Loddon Garden Village - South

DESIGN RESPONSE

Prepared by:	Chris Shaw
Authorised by:	Leigh Abley
Date:	08 July 2025
Document Reference:	A392 – R067 LGV Observer Way RSA 2 Designers Response

Road Safety Audit – Loddon Garden Village - Observer Way Roundabout

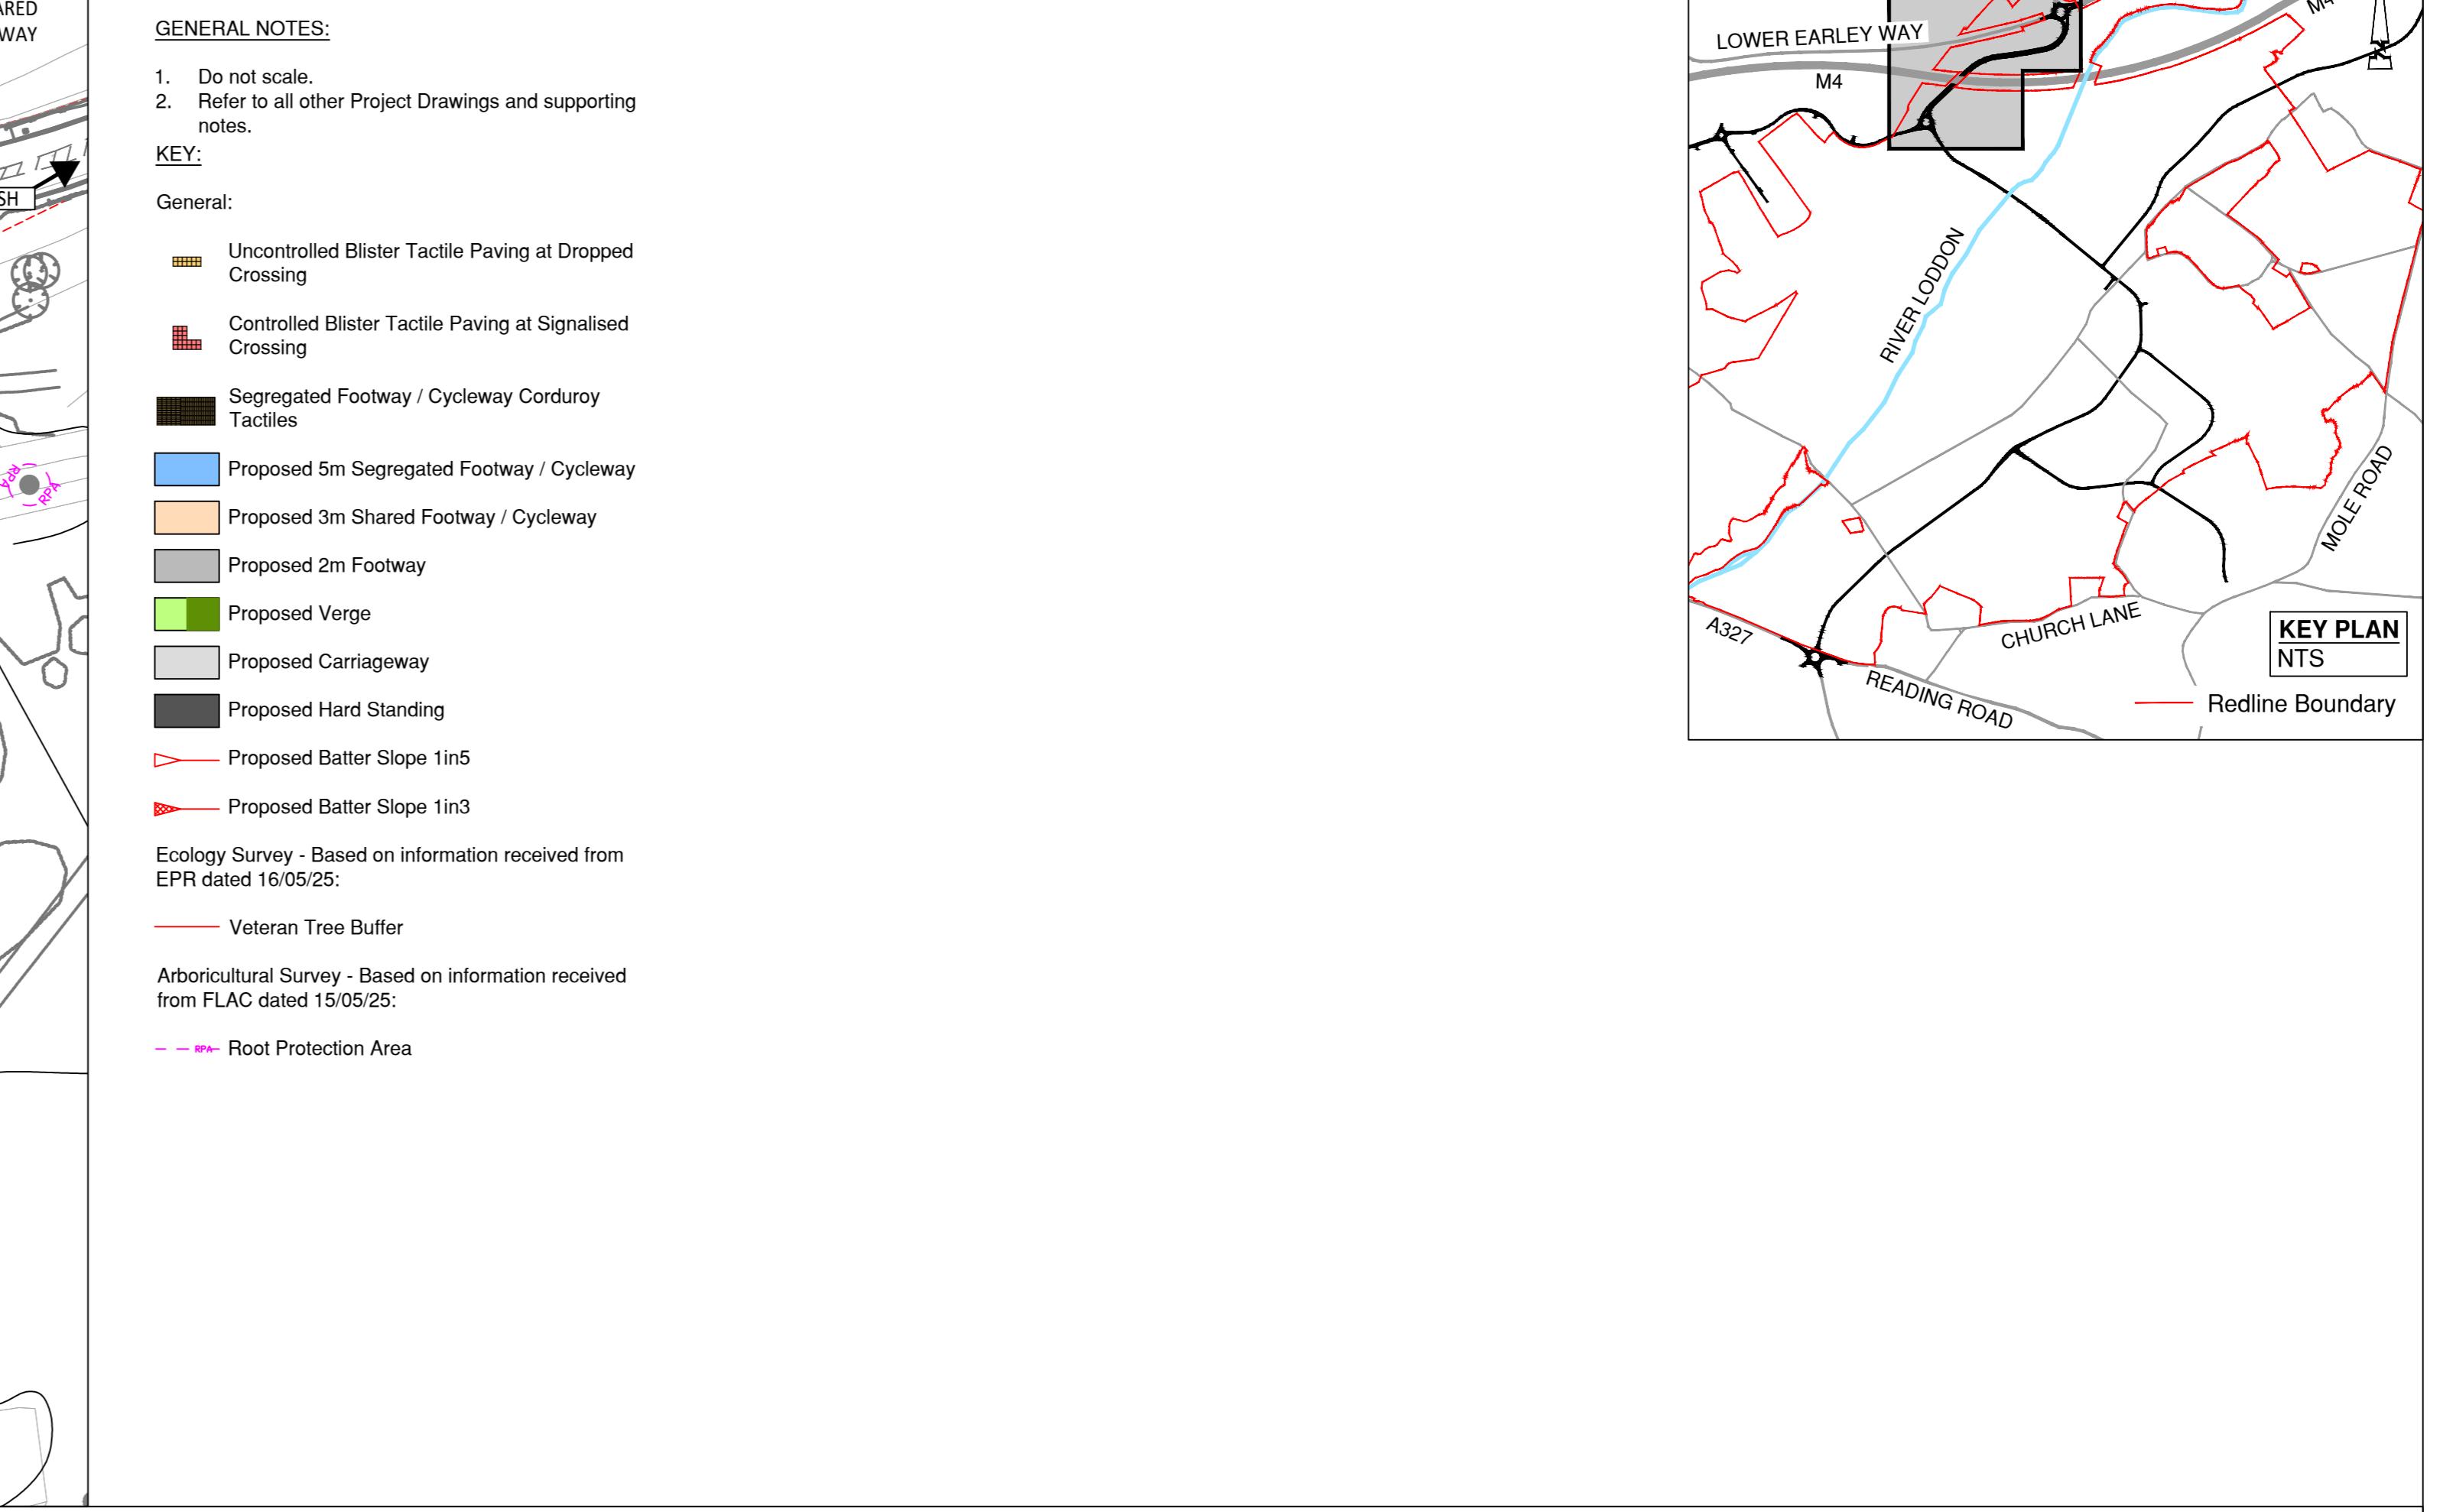
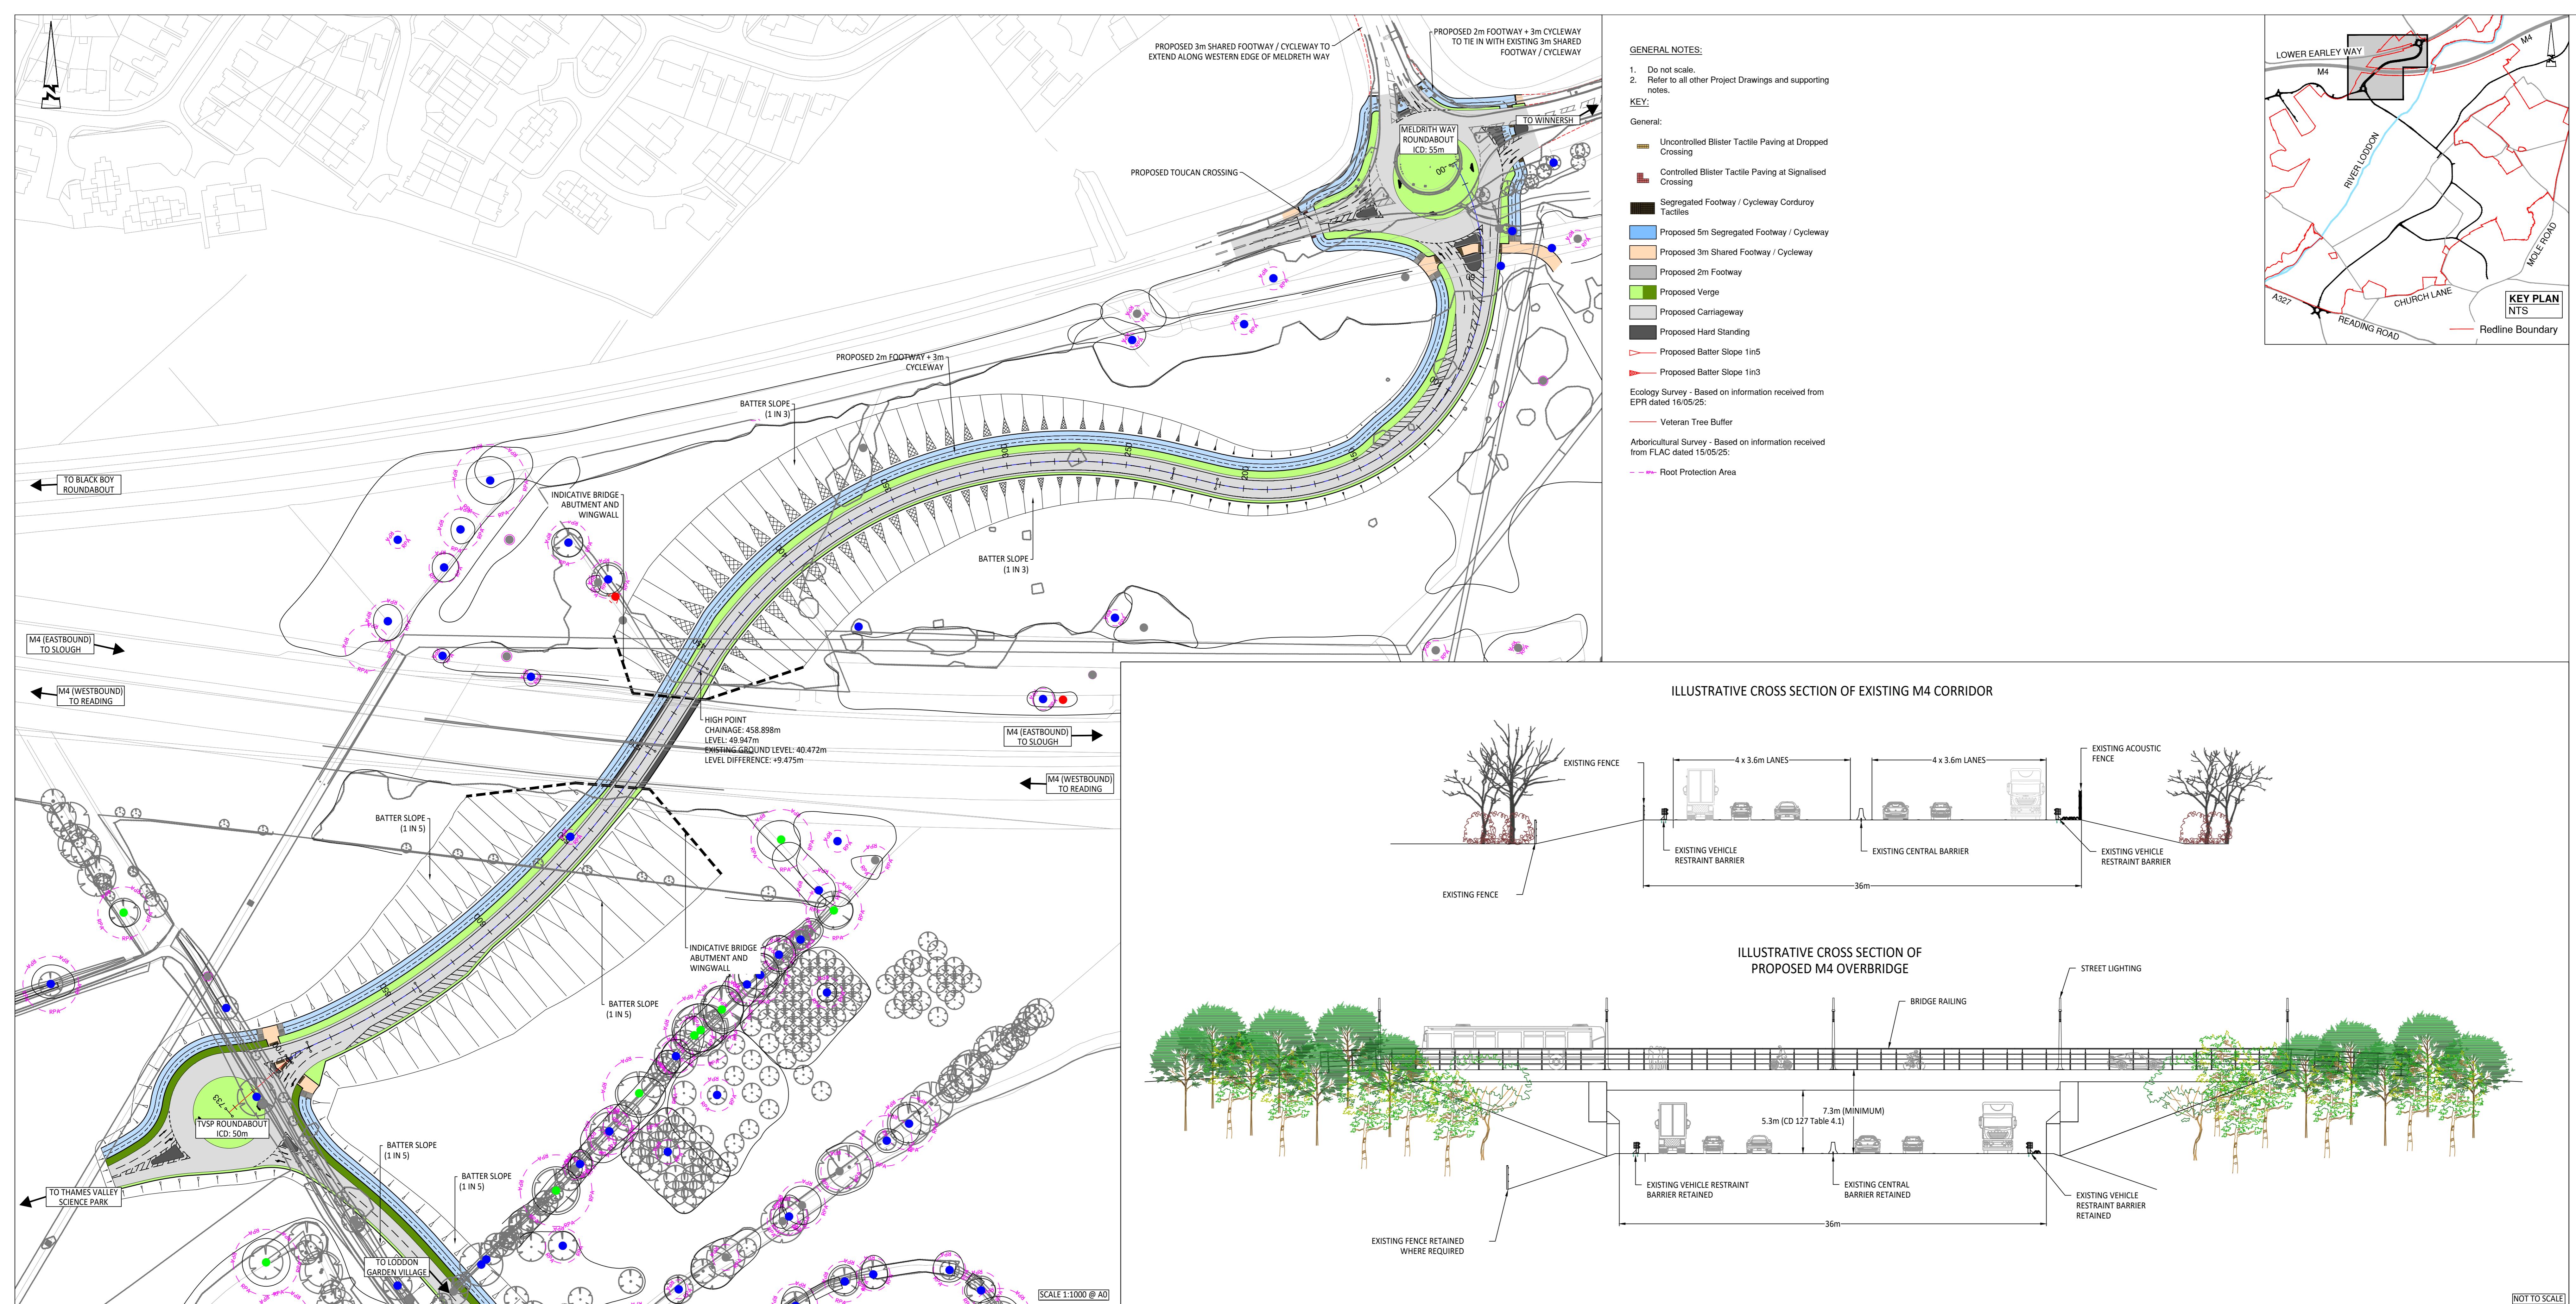
2.1.2 Risk of cycle destabilisation, There is no dropped kerb indicated where cyclists are required to rejoin the carriageway. Cyclists making this manoeuvre may become destabilised and fall, resulting in injury.

2.2.2 Risk of cycle destabilisation, It is not clear from drawing 0701 whether a dropped kerb is being provided where cyclists are required to mount the shared use path. If no dropped kerb is provided, cyclists making this manoeuvre may become destabilised and fall, resulting in injury.

2.3.2 Risk of vehicles colliding with splitter islands, No reflective bollards have been indicated on the noses of the new splitter islands around the roundabout. These may constitute a collision hazard in darkness or inclement weather.

2.4.2 Risk of junction collisions, Some saplings have been planted in this area. As they grow and mature they will restrict visibility to the right for drivers emerging from the new road, increasing the risk of an emerging vehicle being struck by a vehicle entering the roundabout from the north-west.

2.5.2 Risk of cycle destabilisation, There is no dropped kerb indicated where cyclists are required to mount the shared use path. Cyclists making this manoeuvre may become destabilised and fall, resulting in injury.

2.8.2 Risk of driver distraction, It is not recommended to include other carriageway markings within crossing zig-zags, to avoid driver distraction where they should be concentrating fully on the crossing ahead.

2.11.2 Risk of user confusion and vehicle/pedestrian or vehicle/cycle collisions. The crossing indicated on the drawings includes a striped zebra-style crossing, however the crossing is signal controlled, therefore the zebra stripes are not appropriate. Pedestrians or cyclists crossing may interpret the markings as a crossing where they have priority, and try to cross when the signals are at green for motorists, increasing the risk of being struck by a passing vehicle.

2.12.2 Risk of vehicles colliding with refuge islands. No reflective bollards have been indicated on the noses of the refuge islands on the new road. These may constitute a collision hazard in darkness or inclement weather. Furthermore, the length of tapered hatching on the approaches to the islands appears to be significantly shorter than that recommended in Traffic Signs Manual Chapter 5, which may increase the risk of vehicles colliding with the islands.

2.13.2 Risk of vehicle/pedestrian collisions, The tactile paving indicated does not stretch for the full width of the paths where they cross the side roads. There is a risk that pedestrians with a sight impairment may miss the tactiles and walk into the carriageway without realising they are doing so.

2.14.2 Risk of driver confusion, The locations where paths cross the side roads feature two solid lines across the side road carriageway. It was not clear to the auditors if these indicate carriageway markings, however if they are, they would indicate a stop line, which is inappropriate and may confuse drivers.

2.15.2 Risk of driver confusion, The zig-zag layouts of both crossings appear incorrect. They should be opposing on the approach, and parallel on the exit.

2.1.4 Dropped kerb to be provided and materials plan updated to reflect this.

2.2.4 Dropped kerb to be provided and materials plan updated to reflect this.

2.3.4 Bollards to be provided

2.4.4 Saplings to be removed / relocated.

2.5.4 Dropped kerb to be provided and materials plan updated to reflect this.

2.8.4 Road markings to be relocated.

2.11.4 Traffic signals to be removed to provide a tiger crossing rather than a signalised crossing.

2.12.4 Bollards to be provided and tapers to be reviewed and amended accordingly.

2.13.4 Tactile paving to be extended.

2.14.4 Drawing will be amended to avoid confusion and transverse kerbs will be included in appropriate materials plans.

2.15.4 Road markings to be amended
